Addendum to the
Environmental Impact
Assessment Report

NISA
North Irish Sea Array

Chapter 14

Marine Mammal Ecology

Graph A14.1: Auditory weighting functions for low frequency (LF), high frequency (HF) and very high frequency (VHF) cetaceans as well as phocid (PCW) pinnipeds in water Source: NMFS, 2024 (Replaces Graph 14.1 in Chapter 14 of the 2024 EIAR).

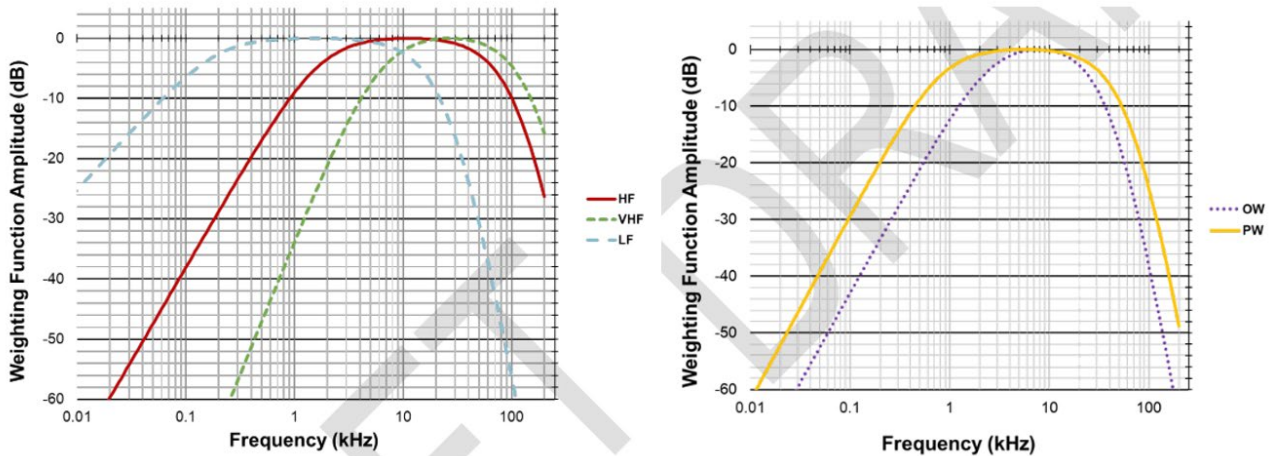
Therefore, for the cumulative sound exposure level (SEL_{cum}), sound has been weighted based on species group specific weighting curves given in NMFS (2024) (Graph A14.1).

Graph 14.1 in Chapter 14 of the 2024 EIAR shall be deleted and replaced with Graph A14.1:
